**ADDENDUM NO. 1**

**BID NO. 24-08  
SIDEWALK CONNECTIVITY**

**SIDEWALK CONNECTIVITY**  
REVISED DRAWINGS  
PER ADDENDUM NO. 1  
02-23-2024

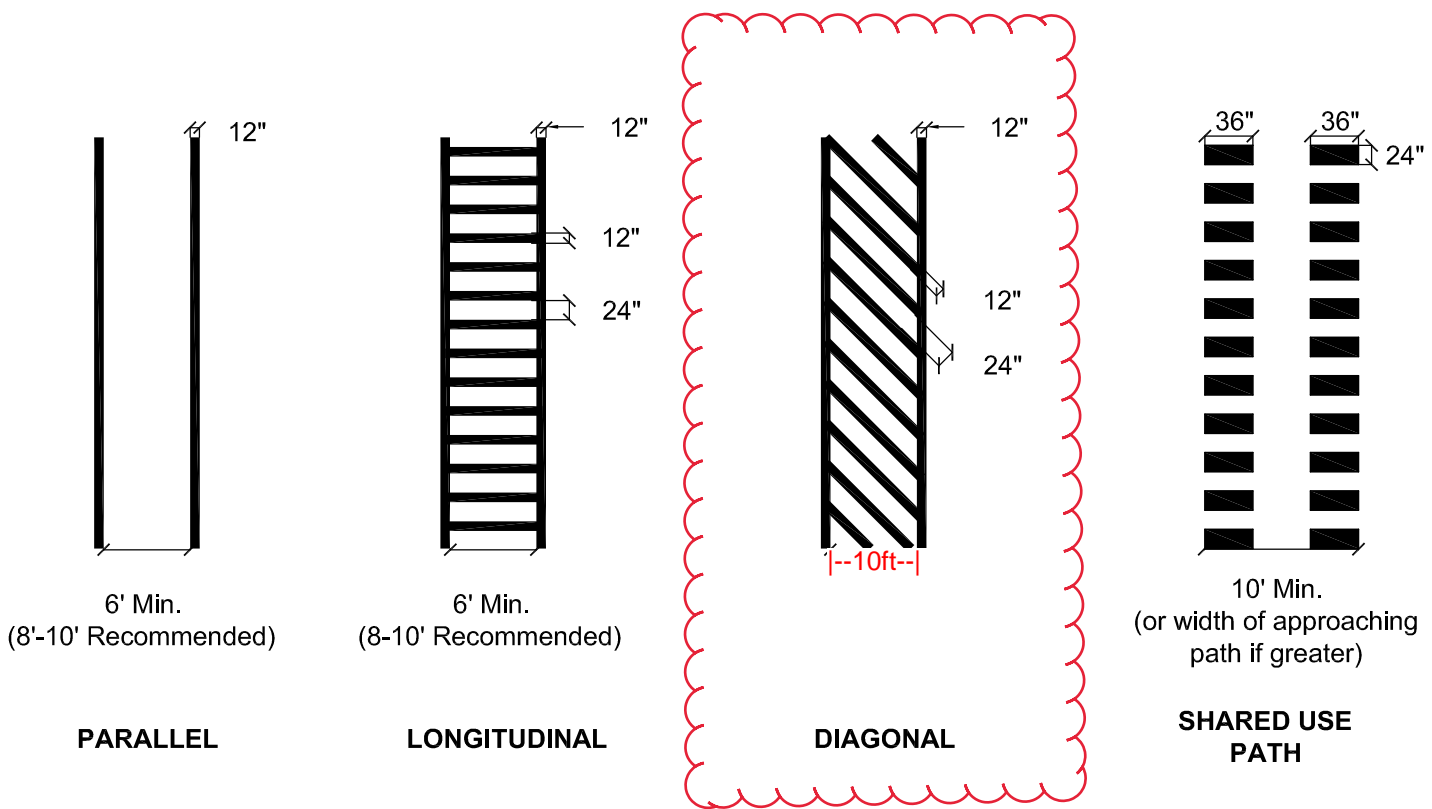
Q4: Can you clarify the drawings and descriptions for the Cambridge Ave area? The description differs from what is shown on the included concept drawings.

Q5: On Edmund St there is a hydrant and mailbox where the new sidewalk will be installed. Would this be removed? Would you rather do the sidewalk around these two items so that we do not touch the items that are in place?

**A4: Please see the attached revised drawing for this area. The concept has been corrected to be consistent with the descriptions in SP-1.4.**

**A5: The proposed sidewalk in this area shall go around the existing hydrant and mailbox as described in SP-1.4.2.1. Please see the attached revised drawing for this area. The concept has been corrected to be consistent with the descriptions in SP-1.4.**

**Figure 10.5 - Crosswalk Marking Types**  
(Sheet 1 of 3)

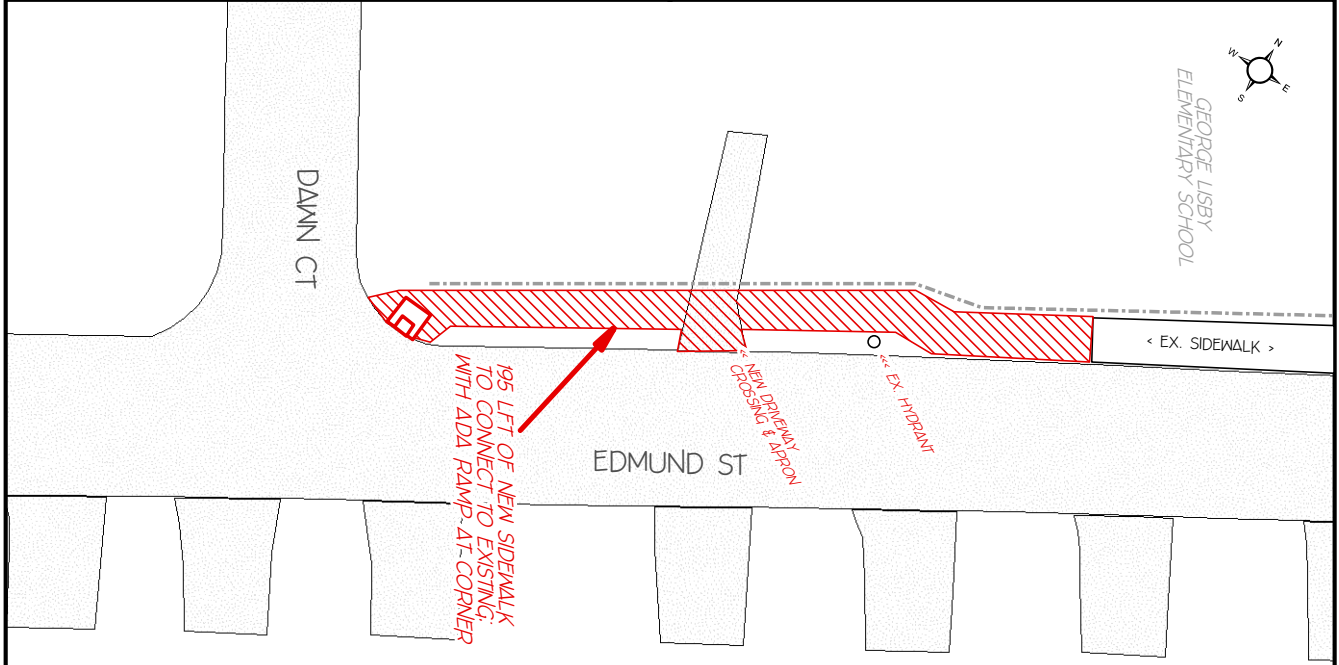
Q3: What are the specifications on the proposed crosswalks mentioned in 1.3.6 & 1.3.8?

**A3: The thermoplastic asphalt striping crosswalks at these locations shall be 10' (ten feet) wide, conforming to the enclosed Maryland MUTCD Figure 10.5 for Diagonal Crosswalk Markings. Any existing crosswalk shall be removed and replaced per this specification. (Note: The existing ADA ramp on the southeast corner of this intersection is to remain as is and will not be replaced at this time.)**
